MIL-I-83456(USAF)
AMENDMENT 2
2 June 1976

MILITARY SPECIFICATION

INSTALLATION OF SEGMENTED LIGHTNING DIVERTER STRIPS ON
AIRCRAFT RADOMES, GENERAL SPECIFICATION FOR

This amendment forms a part of Military Specification
MIL-I-83456(USAF), dated 20 December 1974, and is
approved for use by all Departments and Agencies of
the Department of Defense.

FIGURE 2. Current test waveform components for evaluation of direct effects.

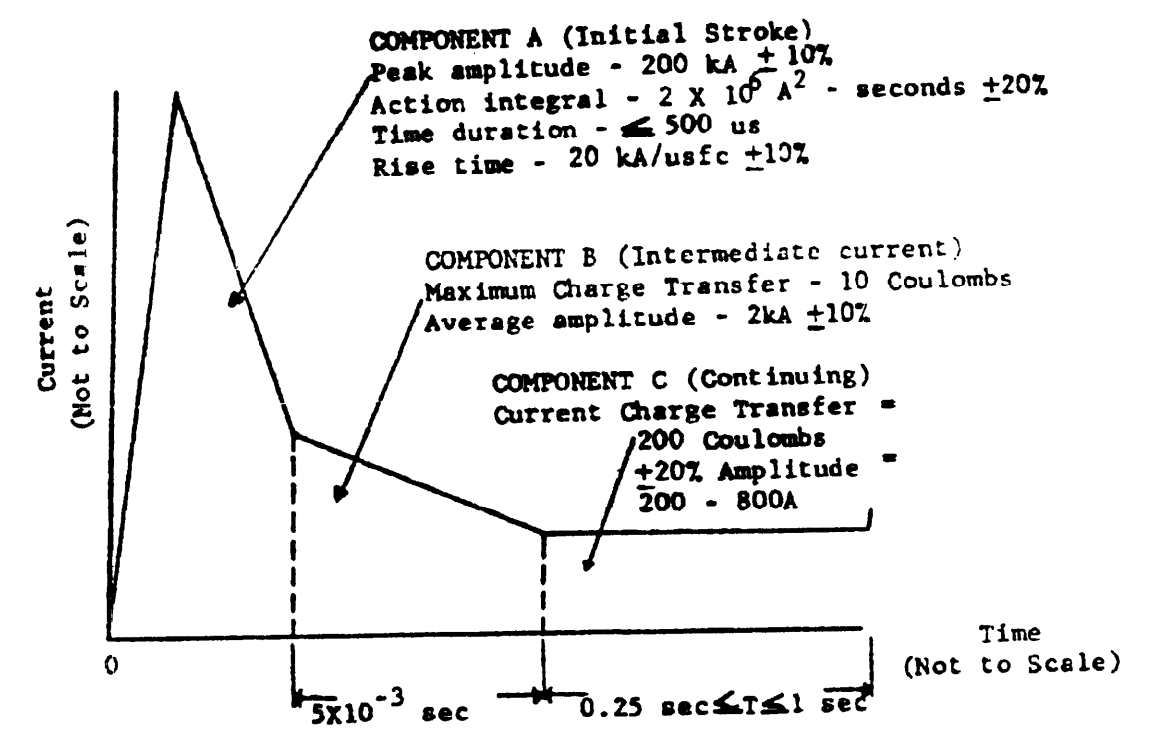
Appendix B, paragraph 20, Delete and substitute:

"Tests of radomes require application of multiple waveform
components I-A and I-B in one discharge and of waveform I-C

in a separate discharge, see figure 2. The level of charge transfer (I-C) for nose radomes and other radomes in Zone IA** area shall be determined for each individual weapon system and radomes from the equation

$$K \frac{LE}{S_0} = C_T \quad *$$

C_T = Charge transfer, in coulombs, required for continuous current test where $10 \text{ coulombs} \leq C_T \leq 200 \text{ coulombs}$.

* L_E = Equivalent radome length in feet for protection devices from pitot tube to airframe equivalent length includes radome length and pitot boom length. For protection devices not originating at (protecting) the pitot boom equivalent length is the length of the protection device.

S_0 = Minimum aircraft stall speed in knots, possible in a lightning environment.

K = 475 amps conversion factor, includes conversions to standardize units and maximum charge transfer coefficient.

** Zone IA = Initial attachment point with low probability of flash hang-on, such as a leading edge.

*** Zone IB = Initial attachment point with high probability of flash hang-on, such as a trailing edge.

For radomes in Zone IB*** area the levels specified in figure 2 shall apply."

FIGURE 3. Fast rate of change current waveforms for evaluation of indirect effects.

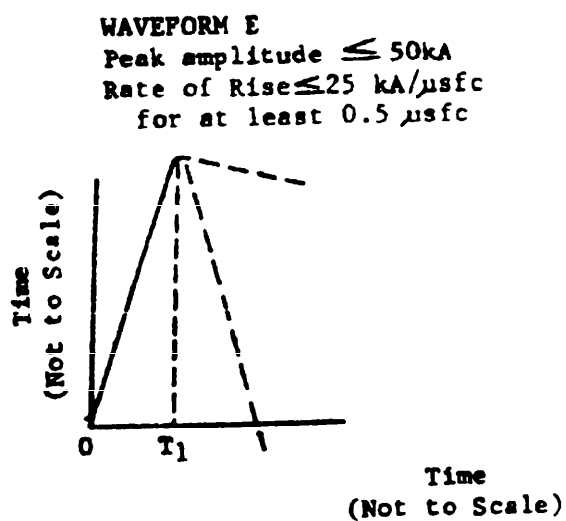
"To measure the indirect effects of lightning, the waveform and specifications of figure 3 shall be used. The current risetime shall be the maximum available from the generator. The results of the measurement shall be extrapolated linearly to the 200 KA peak, 100 KA per microsecond risetime levels."

Add figure 3. Figure 3 forms page 4 of this amendment.
